*LUCAS COUNTY
PLAN COMMISSION
REPORT*

REF: Z19-C633
DATE: June 24, 2015

- Request - Zone Change request from RA-4 *Rural Residential* to R-3 PUD *Multiple Family Residential Planned Unit Development*
- Location - 7371 and 7405 W. Bancroft Street, Springfield Township
- Owner - Chase C. Eichhorn
3201 E. Lincolnshire Blvd.
Toledo, OH 43606
- Owner - Edgebrook Dev. Co.
5135 S. Main Street
Sylvania, OH 43560
- Applicant - McCarthy Builders
3618 King Road
Toledo, OH 43618
- Engineer - George Oravec, P.E., P.S.
Oravec & Associates
5333 Secor Road
Toledo, OH 43623

PLANNED UNIT DEVELOPMENT PLAN

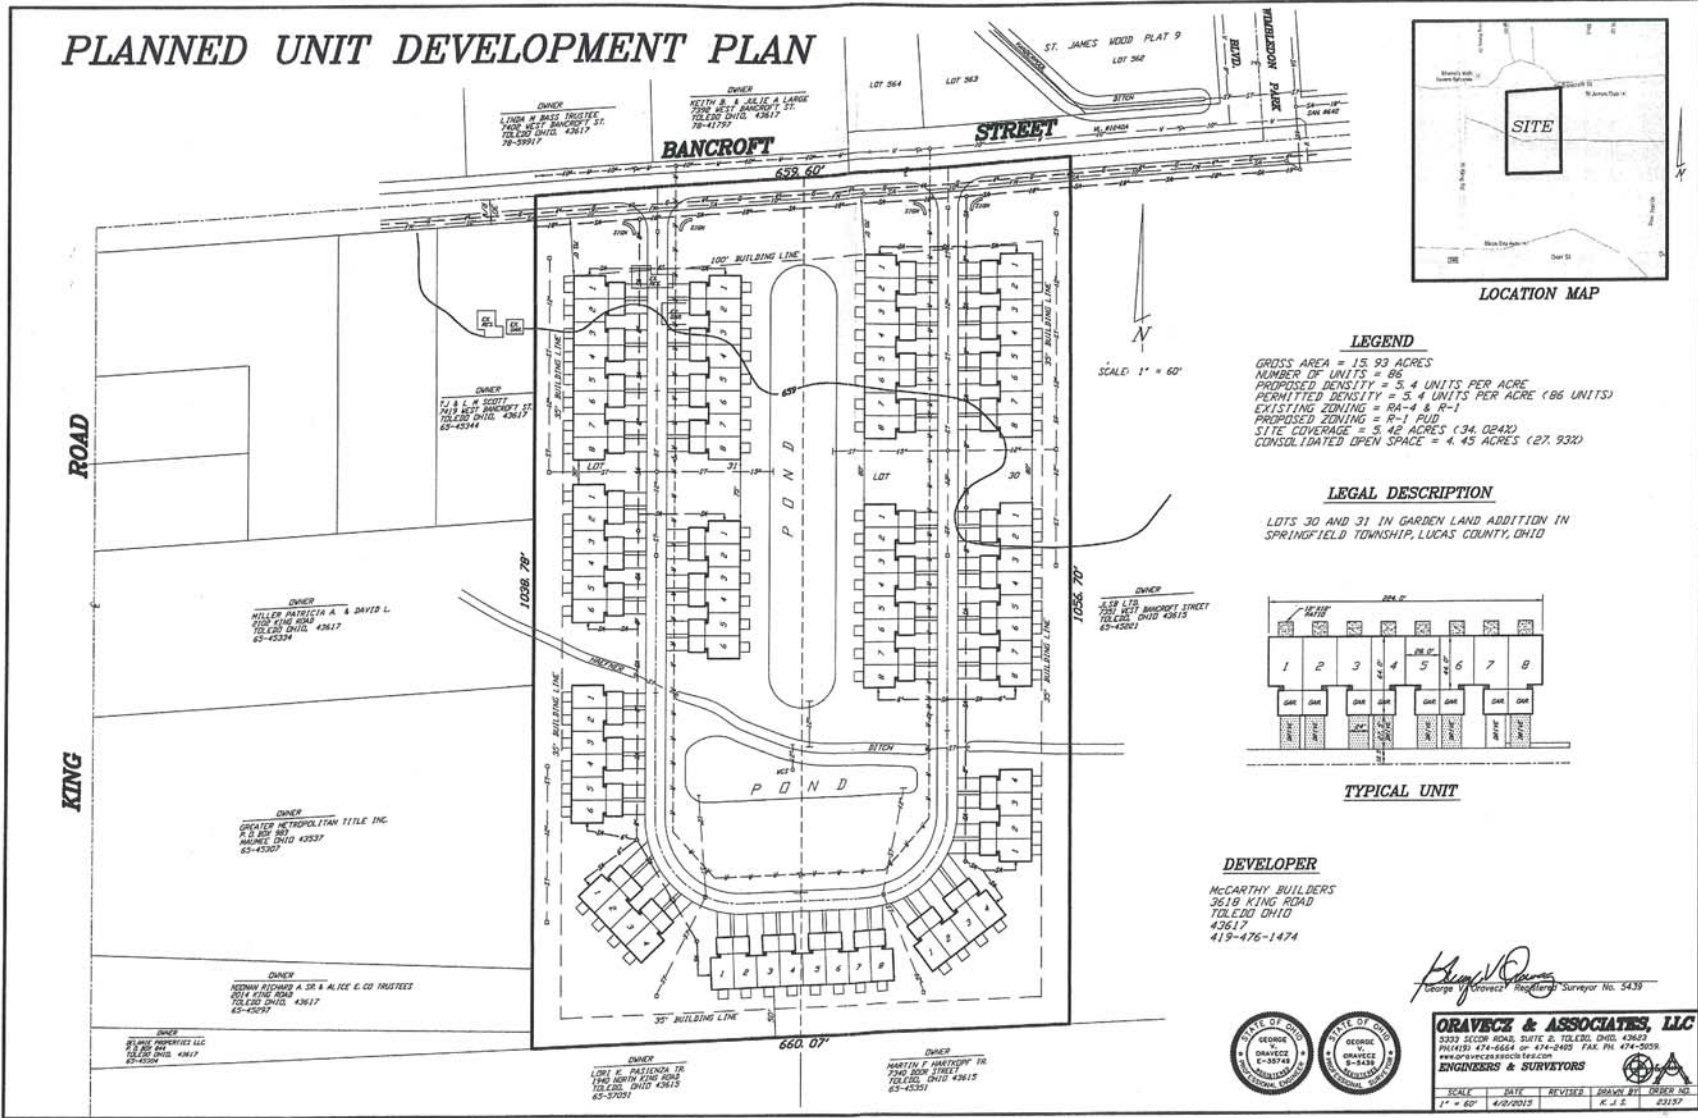
The project proposes a total of 86 single family residential, row style apartments on one parcel. The overall density for the project is 5.4 units per acre. The project was designed for an R-1 PUD, which allows a maximum density of 5.4 units per acre. An R-3 PUD was required in order to construct multiple buildings on a single parcel. The R-3 PUD allows a maximum density of 11.2 units per acre. At 5.4 units per acre, the project is closer to single family residential, not multi-family residential. Additionally, the development plan will lock the project into the lower density of 86 units.

The units will access Bancroft Street using an internal driveway that loops around the property. The Zoning Resolution requires one and a half parking spaces per unit. These spaces will be provided through individual driveways and garages. Because there is one parcel, a subdivision with a dedicated roadway is not required. All private driveways are subject to access management with Lucas County Engineer's Office. In order to provide improved traffic operations and access management only one driveway access point will be permitted.

A secondary connection to adjacent parcels for future development could accommodate an additional access point and is also required per the Springfield Township Zoning Resolution. It appears that there is room within the existing layout, between buildings, for a future connection to be made to the east. Any secondary connection shall remain open to two way traffic and not be restricted in any way.

The coverage of buildings, pavement, and other impervious surfaces shall not exceed 40% of the gross site acreage. The coverage for the project is currently 34%, which appears to meet zoning requirements. A breakdown of elements included in the coverage calculation shall be included on a revised plan to verify compliance. Springfield Township also requires at least 15% of total gross acreage be set aside for consolidated common open space. The intent is that meaningful, functional areas are created for residents and the community. The plan indicates that consolidated open space is 27.9% of the total project, but does not specify the area that is used for calculations. This area shall be delineated on the plan and a breakdown calculation of pond area and useable space shall be provided. Additionally, the Springfield Township Zoning Resolution encourages the utilization of bike and pedestrian pathways, possibly along the pond or ditch area.

1. The owner, address, & parcel number should be located on each proposed developed, parcel.
2. Water is available to this site via W-1248A-10" on Bancroft Street for parcel 65-45248 and via W-1473-10" on Bancroft Street for parcel 65-45271. The aforementioned waterlines shall be called out as such.

3. The watermain in the subdivision shall be clearly labeled as "PRIVATE". The point of connection at any "PUBLIC" watermain shall be labeled clearly, "BEGIN PRIVATE WATERMAIN".

4. All watermain connections to the "PUBLIC" system shall include a check valve at all connection points. A "Private" valve in a manhole shall also be installed after the check valve.

6. The proposed 18" sanitary sewer on Bancroft Street shall be labeled as S-908-18".
7. The existing 10" force main on Bancroft Street shall be labeled as S-693-10". There is also an existing 4" force main on the North side of Bancroft Street. This force main shall be shown and labeled as S-213A-4".

9. The sewer main in the subdivision shall be clearly labeled as "PRIVATE". The point of connection at any "PUBLIC" sewer main shall be labeled clearly, "BEGIN PRIVATE SEWER MAIN".

- a. To provide improved traffic operations and access management, utilize one roadway connection to Bancroft Street rather than two. The proposed westerly driveway location does not meet the required spacing to the existing driveway for the residential property to the west.

30. Provide 35 foot minimum uncurbed radii at the intersection of Bancroft Street and the development entrance. Pavement grading on the development entrance must direct storm runoff away from Bancroft Street.

31. A thirty (30) foot riparian setback is required for Haefner Ditch and shall be shown on the plans. Structures are not permitted to be located in this setback.

41. A revised Planned Unit Development drawing shall be submitted to the Springfield Township Zoning Department. The revised plan shall include:
 - a. A breakdown showing all elements (buildings, internal drive, driveways, paved patios, sidewalks) included in the coverage calculation.

- b. A delineation on the plans showing the area used for consolidated open space.
 - c. A breakdown showing all elements (ponds, useable open space) included in the consolidated open space calculation.

- d. Secondary driveway connections to adjacent parcels for future developments.
 - e. A note indicating that the internal drive and all proposed connections are available for public use. There shall be no restrictions on access.

- f. Corrected zoning information. Existing zoning is RA-4. Proposed zoning is R-3 PUD.
42. The site includes two properties. The parcels should be combined by filing an "Application for Combination" at the Lucas County Auditor's office. The combination will address potential zoning conflicts regarding setbacks from property lines.
